Technical Bulletin

Model: NAD 30S/30/40 DF (DF67) Date			e: 15-Oct-98		No.: 1		
Subject: Original	MIsfeed			Prepared	d by: S. H	Hizen	
From: GTS and S Field Information Dept.							
Classification: Troubleshooting		☐ Part information		tion	☐ Action required		
☐ Mechanical ☐ Electrical		☐ Service manua		ce manual revision			
	☐ Paper path	☐ Transmit/receive		eive	☐ Retrofit information		
	Other ()

SYMPTOM

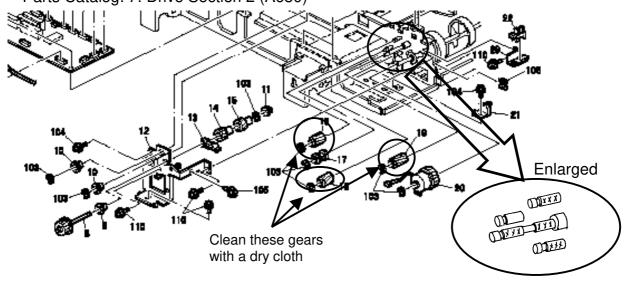
Original feed jam: The original is jammed just after the front edge is fed about 10 cm (A4/LT size) onto the exposure glass.

The friction between the 16Z gear and its shaft increases and exceeds the maximum torque of the feed motor. This is due to tiny burrs on the shaft.

File off the tiny burrs on the shaft and lubricate as shown in the following procedure.

- 1. Take off the retaining rings for the 16Z gears.
- 2. File the shafts using fine sandpaper. (Do not use a metal file to file the shaft because this will increase the friction.)
- 3. Clean the shafts and the inside of the gears with a dry cloth.
- 4. Lubricate the shafts and the inside of the gears with plastic grease (white resin based grease for plastic parts).
- 5. Reassemble the gears and the rings.
- Parts Catalog: 7. Drive Section 2 (A680) -
